**HUGHES
SERVICE INFORMATION
NOTICE**

NOTICE NO. N-168
DATE 18 July 1980
PAGE 1 OF 4

SUBJECT: REWORK OF PILOT SEAT CUSHION ASSEMBLY, PN 269A4039

MODELS AFFECTED: Model 269C Helicopter Serial No. 0003 through 0959

Figure 1. Rework of pilot seat cushion assembly

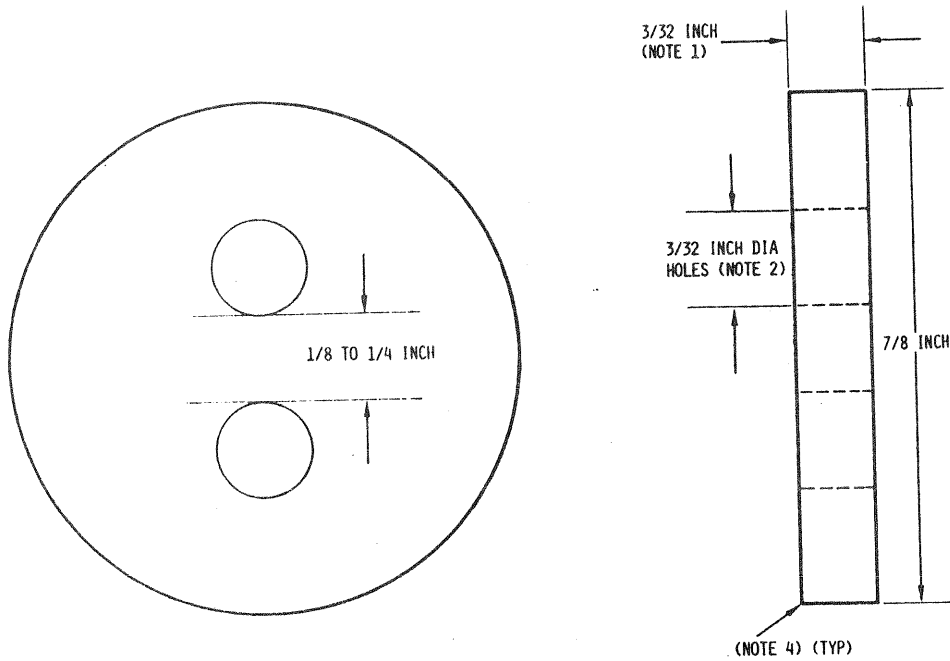
- a. Remove pilot seat cushion assembly.
- b. Install four upholstery buttons on bottom seat cushion at dimensions shown (see Figure 1):
 1. Use lacing tool (see Figure 2) to insert lacing through one button hole, through upholstery seat cushion and cover, and through hole in opposite button. Insert lacing in reverse direction through buttons and seat cushion and cover.
 2. Tighten and tie off lacing so that buttons are flush to 1/4-inch compressed into the cushion.
 3. Repeat steps 1 and 2 above for remaining two upholstery buttons
- c. Reinstall pilot seat cushion assembly.
- d. With pilot seat occupied, check that cushion bottom side cover does not contact the collective friction lever. Tighten lacing to further restrain cushion cover as required.
- e. Record compliance with this Service Information Notice in Compliance Record of helicopter Log Book.

NOTE:
TIGHTEN AND TIE OFF LACING SO THAT
BUTTONS ARE FLUSH TO 0.250 INCH
COMPRESSED INTO CUSHION.

Figure 2. Field fabrication - lacing tool and upholstery buttons

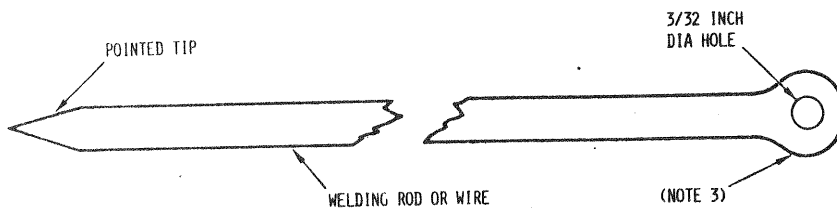
1. ALUMINUM SHEET OR ABS PLASTIC SHEET (BOLTERON, ETC)
2. TWO HOLES EQUAL DISTANCE FROM CENTER OF BUTTON
3. FLATTEN ONE END OF ROD AND DRILL HOLE TO ACCOMMODATE LACING
4. BREAK OR ROUND OFF SHARP EDGES
